PLANNING AND ZONING COMMISSION
Wednesday, February 18, 2026, 4:30 PM
191 5th Street West, Ketchum, Idaho 83340

STAFF REPORT KETCHUM PLANNING AND ZONING COMMISSION REGULAR MEETING OF FEBRUARY 18, 2026

STAFF REPORT
KETCHUM PLANNING AND ZONING COMMISSION
REGULAR MEETING OF FEBRUARY 18, 2026

LIFT VIEW TOWNHOMES
310 GEORGIA RD
RENDERINGS

DRAWING TITLE:
CONCEPTUAL LANDSCAPE
PLAN

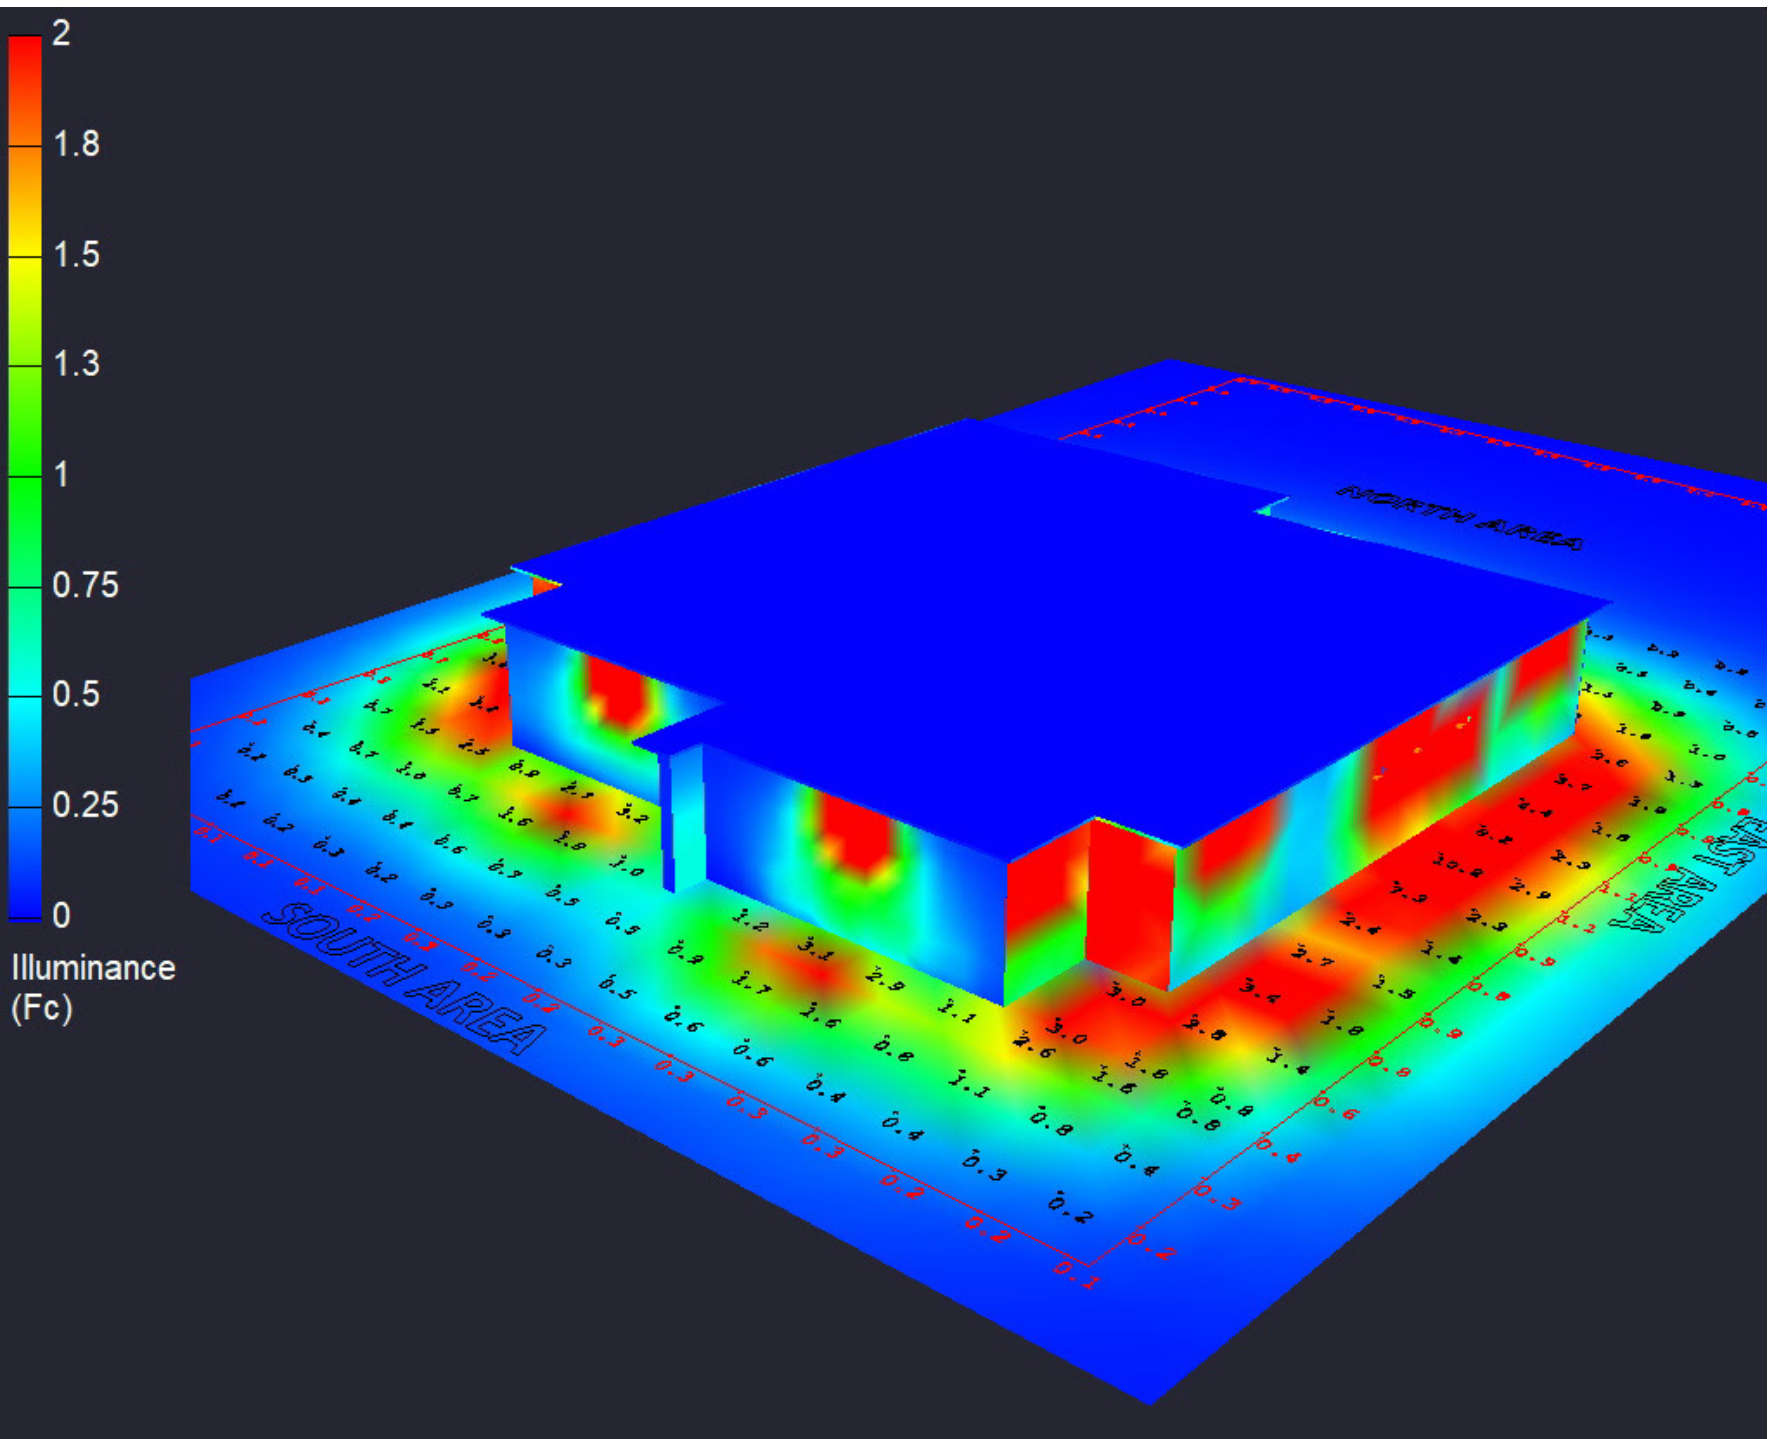
The landscape plan submitted with the application materials underwent a few rounds of revisions during department review to select species that were drought tolerant and offer sufficient screening for the retaining walls that are visible from the street. However, the plant legend on the landscape plan continues to lack all of the proposed plant species, including for both groundcover and reseeding. All species must be indicated on the landscape plan for staff to verify drought tolerance. Staff recommend condition of approval #3 which stipulates that the applicant shall provide a final landscape plan that indicates all proposed plant species and the drought tolerance of each species that is to be reviewed and approved prior to building permit issuance.

17.96.060.I.1 – Landscaping	Conformance
<i>Landscaping is required for all projects.</i>	YES
Finding: Landscaping has been provided for the project as indicated on Sheet L1 of the project plans. As mentioned above, the landscape plan underwent a few rounds of revisions during department review to select species that were drought tolerant and offer sufficient screening for the retaining walls that are visible from the street. However, the plant legend on the landscape plan continues to lack all of the proposed plant species, including for the screening of utilities, groundcover, and reseeding. All species must be indicated on the landscape plan for staff to verify drought tolerance. Staff recommend condition of approval #3 which stipulates that the applicant shall provide a final landscape plan that indicates all proposed plant species and the drought tolerance of each species that is to be reviewed and approved prior to building permit issuance.

3. A final landscape plan shall be provided for review and approval prior to building permit issuance. Said landscaping plan shall provide a detailed plant list indicating all proposed plant species and the drought tolerance of each species.
